RE: Halifax County C&D Landfill
Area 2 – Permit No.42-04

Smith Gardner, Inc. (S+G) is pleased to submit the following responses to your 4-19-13 comments regarding the Design Hydrogeologic Report, the Water Quality Monitoring Plan and the Landfill Gas Monitoring Plan (**attached**). For ease in review, we have included your comments with our responses below.

PROPOSED LANDFILL GAS MONITORING NETWORK

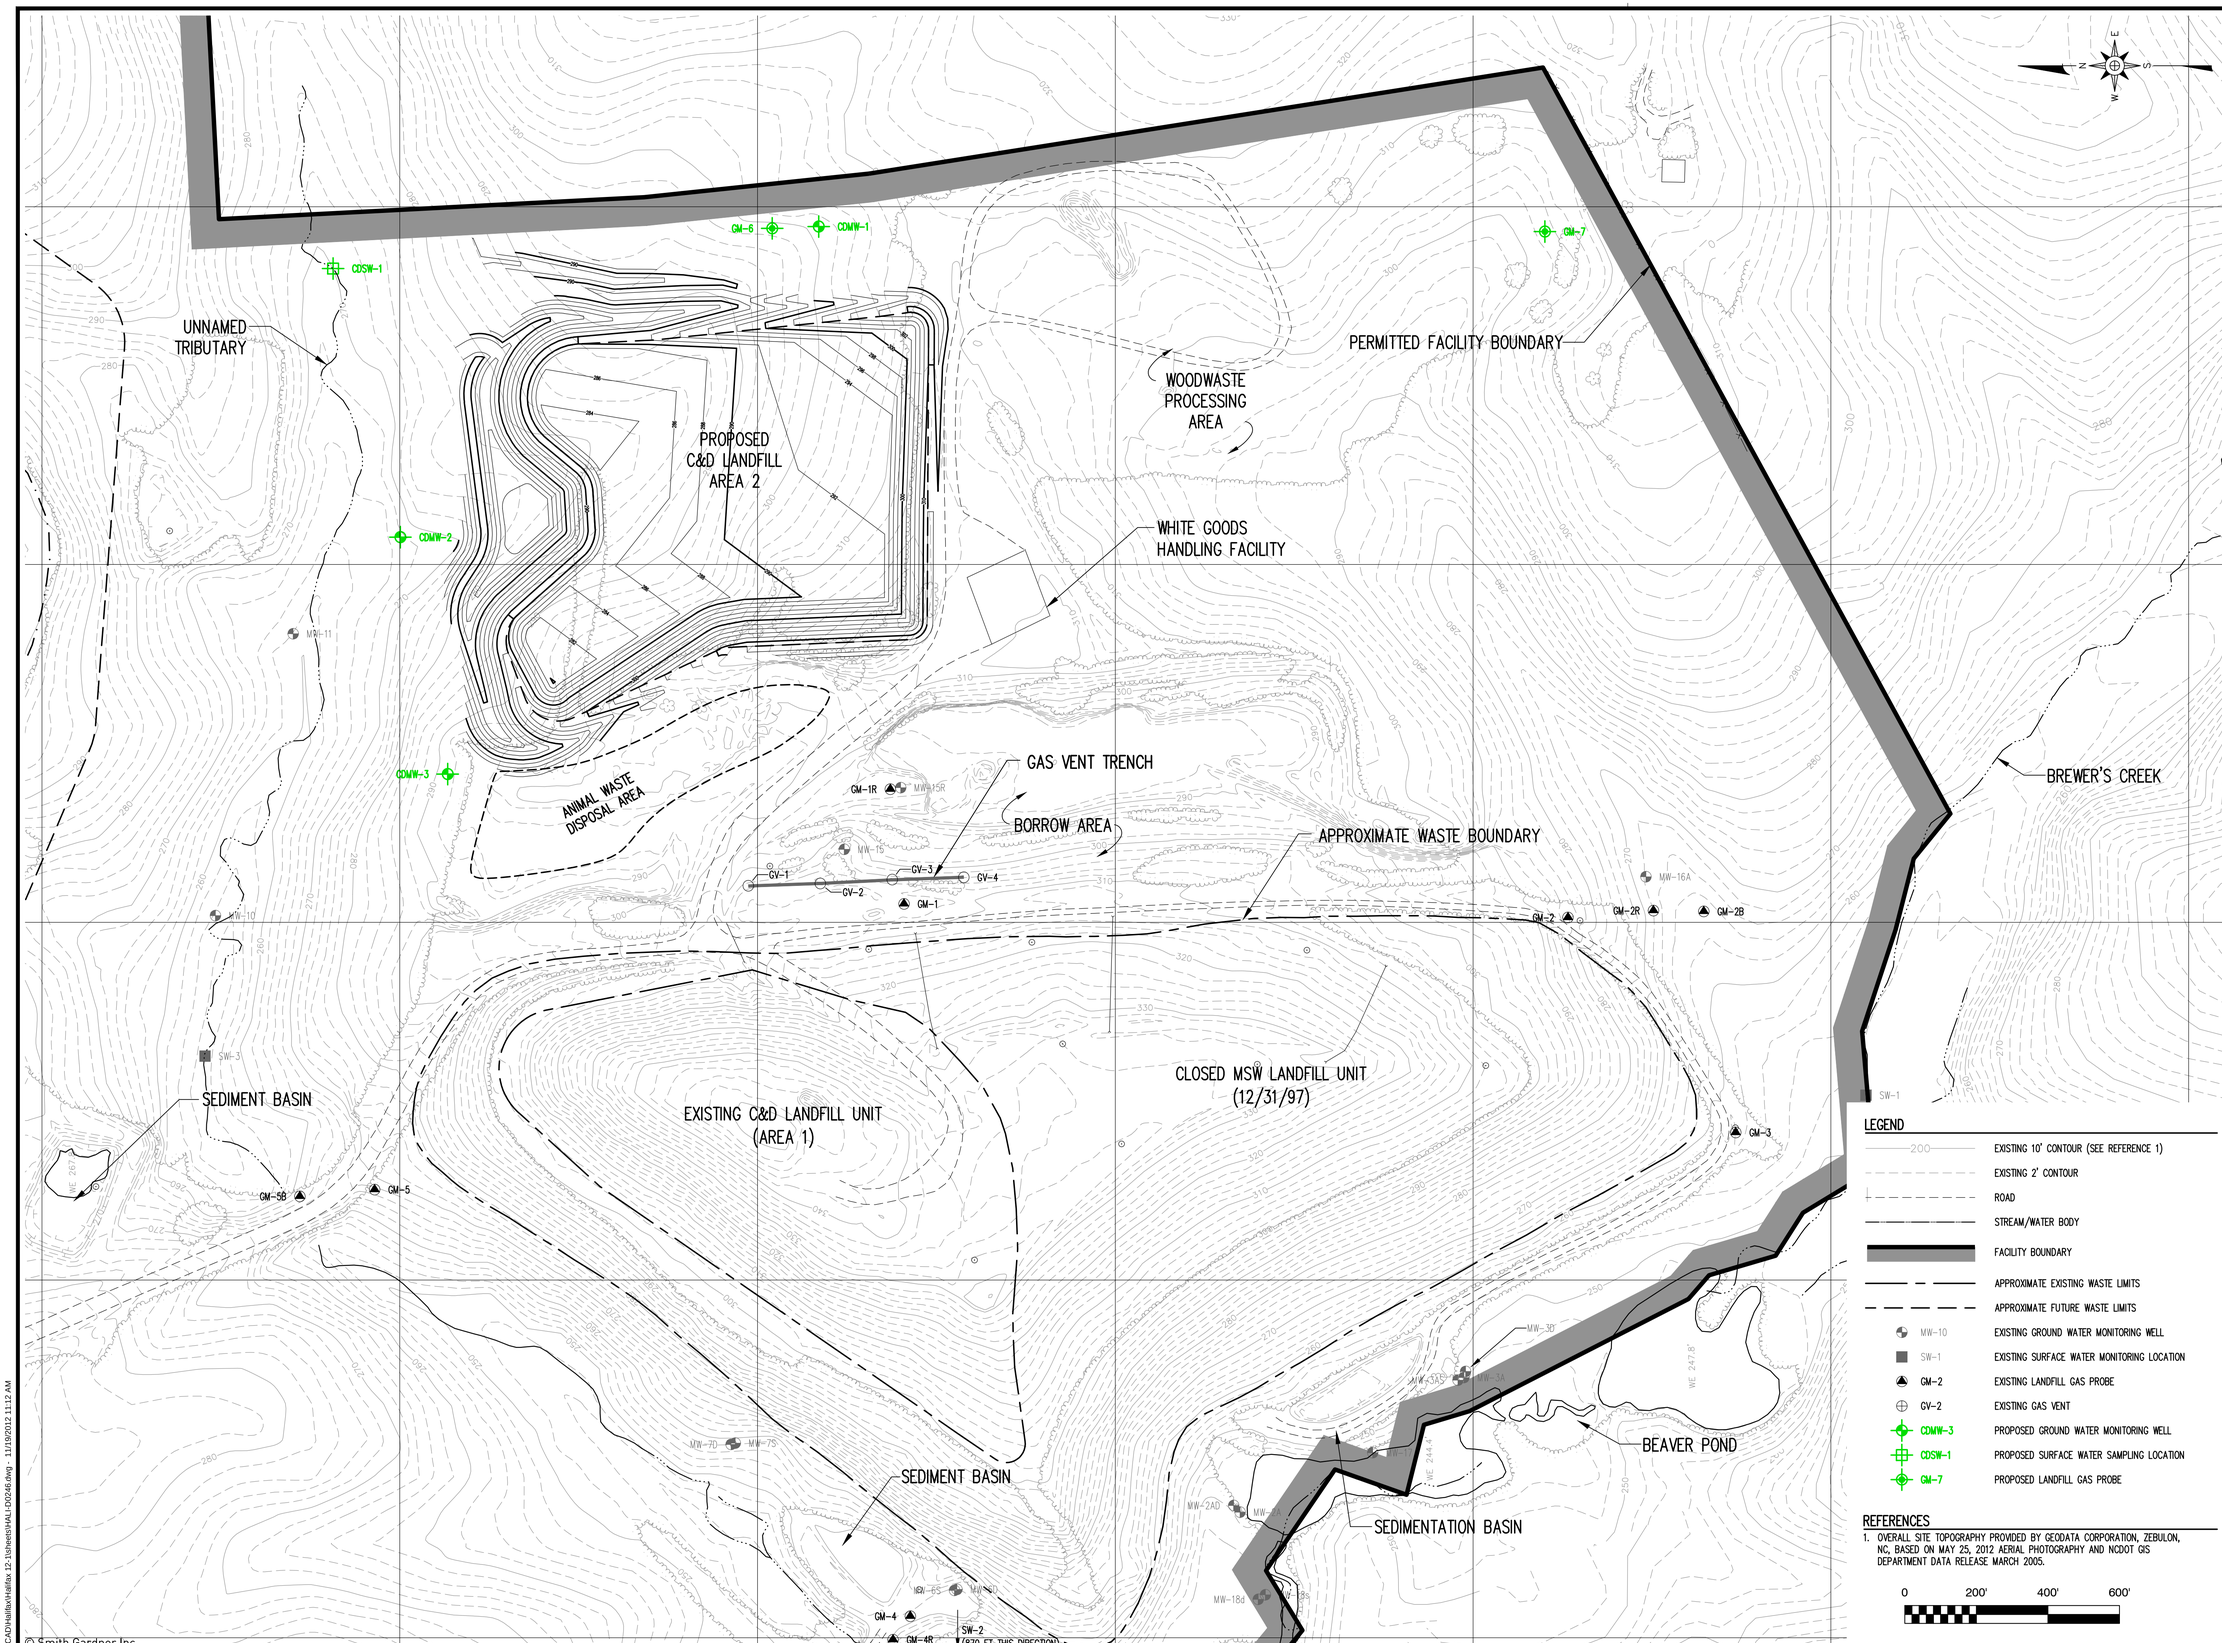
Comment: Figure 2, Proposed Landfill Gas Monitoring Network, shows three proposed surface water sampling locations labeled as CDSW-1, CDSW-2 AND SW-3.

Figure 2, Proposed Landfill Gas Monitoring Network, shows three proposed surface water sampling locations labeled as CDSW-1, CDSW-2 AND SW-3.

Please clarify location and labeling of CDSW-2. If the figure in the LFG Monitoring Plan is correct and CDSW-2 is proposed in addition to CDSW-1 and SW-3, please revise the table and the figure included in the WQMP to include surface water sampling location CDSW-2. If the table and corresponding figure in the WQMP is correct, please revise the figure in the LFG Monitoring Plan to eliminate CDSW-2.

Response: CDSW-2 has been removed from **Figure 2** to reflect only two surface water sampling points, CDSW-1 and SW-3.
